Project	IEEE 802.16 Broadband Wireless Access Working Group < http://ieee802.org/16 >
Title	Re-definition of Mobile Terminal Management Primitives
Date Submitted	2007-03-15
Source(s)	Jaesun Cha and Chulsik Yoon jscha@etri.re.kr ETRI 161 Gajeong-dong, Yuseong-gu Daejeon 305-700 Korea
Re:	Contribution on comments to IEEE 802.16g/D8
Abstract	Re-definition of mobile terminal management primitives
Purpose	Adoption
Notice	This document has been prepared to assist IEEE 802.16. It is offered as a basis for discussion and is not binding on the contributing individual(s) or organization(s). The material in this document is subject to change in form and content after further study. The contributor(s) reserve(s) the right to add, amend or withdraw material contained herein.
Release	The contributor grants a free, irrevocable license to the IEEE to incorporate text contained in this contribution, and any modifications thereof, in the creation of an IEEE Standards publication; to copyright in the IEEE's name any IEEE Standards publication even though it may include portions of this contribution; and at the IEEE's sole discretion to permit others to reproduce in whole or in part the resulting IEEE

Figure 505 – M-MTM primitives flow for Reset / ~~Power On~~ / Power Down at MSSS side

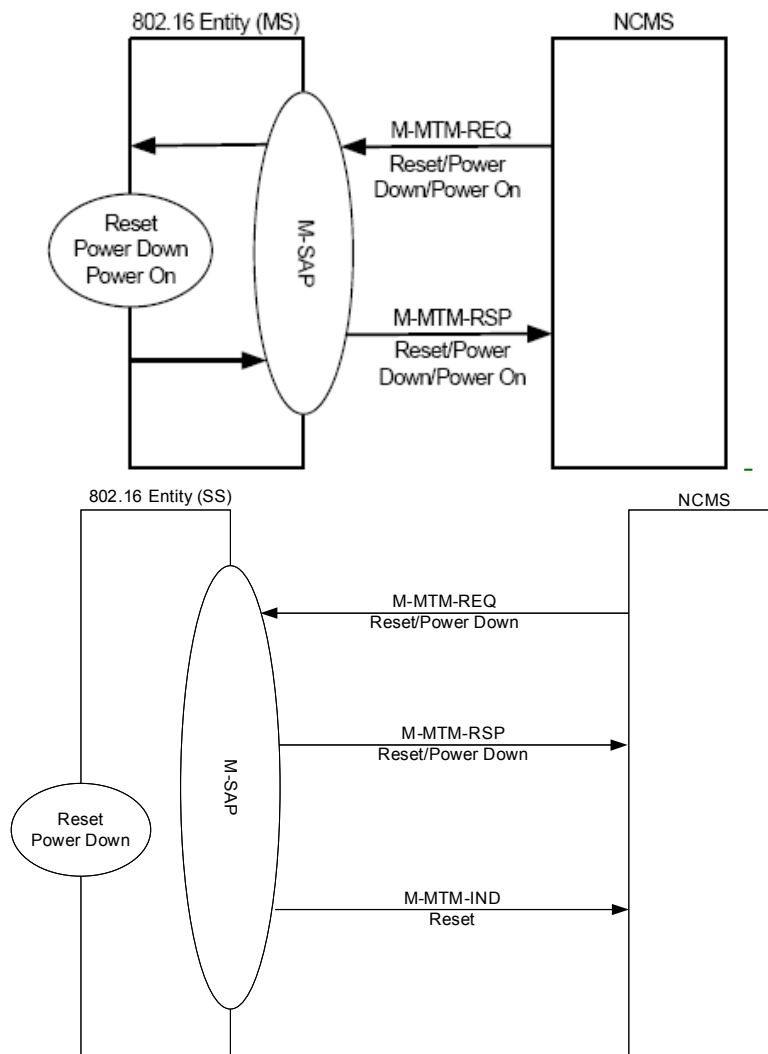
Some of mobile terminal management primitives are not defined correctly. For example, M-MTM-REQ (Power On) primitive is generated to force the terminal to power on. But, the terminal can not receive the primitive because it has already been powered off.

Primitives	Changes	Reason for Changes
M-MTM-REQ (Power on) M-MTM-RSP (Power on)	<ul style="list-style-type: none"> ➤ Remove two primitives ➤ Add a new primitive; M-MTM-IND (Power On) 	<ul style="list-style-type: none"> ➤ We can't give any instruction to the device which is powered off.
M-MTM-REQ (Power Down) M-MTM-RSP (Power Down)	<ul style="list-style-type: none"> ➤ The SS generates M-MTM-RSP (Power Down) primitives before it starts power-down procedure. 	<ul style="list-style-type: none"> ➤ After power-down, the SS can't generate any primitive.
M-MTM-REQ (Reset) M-MTM-RSP (Reset)	<ul style="list-style-type: none"> ➤ If NCMS at SS side generates the request primitive, the SS performs reset procedure after it responds to the request. And then, it generates M-MTM-IND (reset) primitive to notify the NCMS of the completion of reset. ➤ If NCMS at BS side uses M-MTM-REQ (reset) primitive instead of M-MTM-IND (reset) primitive to reset the terminal 	<ul style="list-style-type: none"> ➤ It's better to use one unified primitive to notify the NCMS of a reset event; M-MTM-IND (reset) ➤ The generation of M-MTM-IND (reset) by the NCMS at BS side is not the event notification. It's just a request to reset the terminal

Figure xxx – M-MTM flow for Power On at SS side

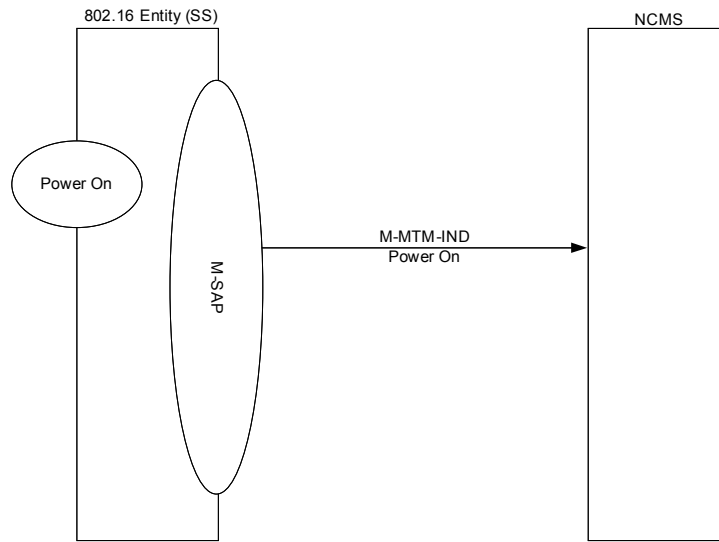
[Add a new Event_Type 'Power On' to the table on page 46]

Figure 507 – M-MTM primitives flow for Hold and Normal resumption

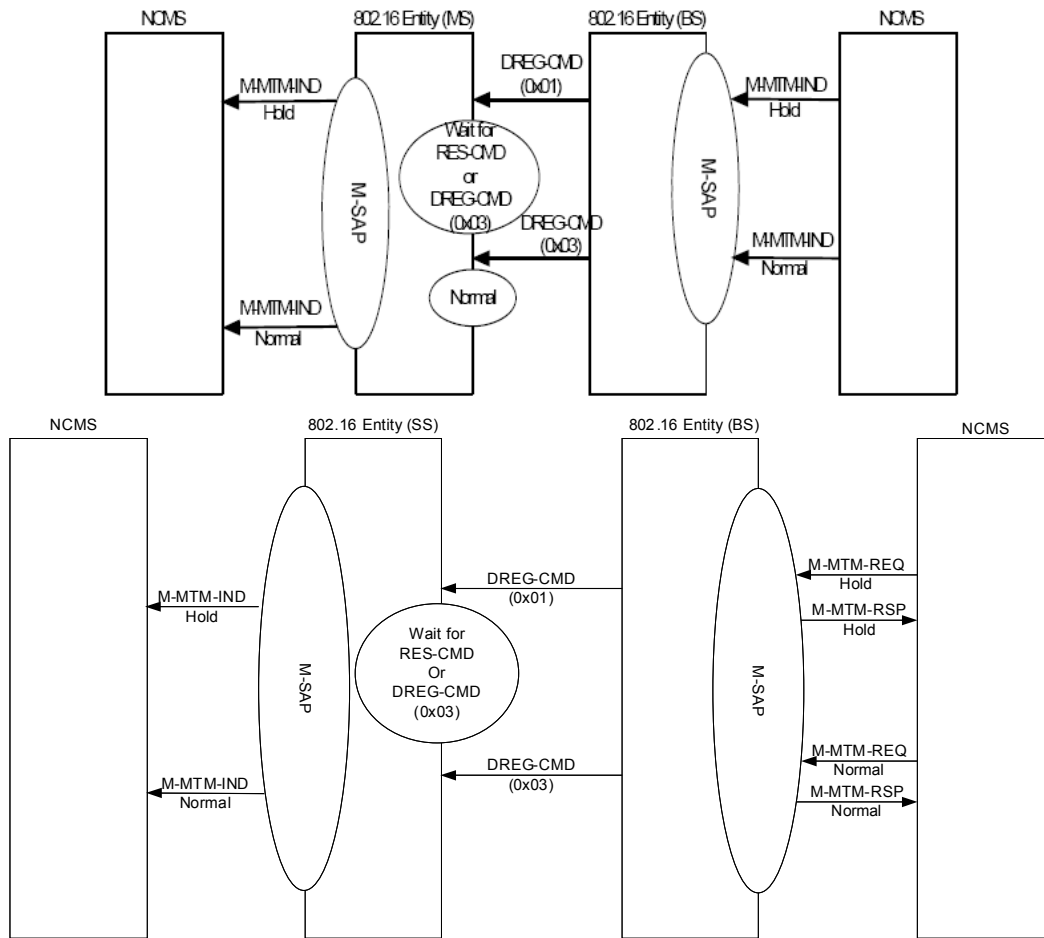
M-MTM-IND (Hold)	<ul style="list-style-type: none"> ➤ Only SS can generate M-MTM-IND (Hold) primitive. ➤ The new primitives are used at BS side; M-MTM-REQ (Hold), M-MTM-RSP (Hold) 	<ul style="list-style-type: none"> ➤ The generation of M-MTM-IND (Hold) by the NCMS at BS side is not the event notification. It's just a request to change the status of the terminal
M-MTM-IND (Normal)	<ul style="list-style-type: none"> ➤ Only SS can generate M-MTM-IND (Normal) primitive. ➤ The new primitives are used at BS side; M-MTM-REQ (Normal), M-MTM-RSP (Normal) 	<ul style="list-style-type: none"> ➤ The generation of M-MTM-IND (Normal) by the NCMS at BS side is not the event notification. It's just a request to change the status of the terminal

[Add two new Action_Type 'Hold' and 'Normal' to the table on page 45]
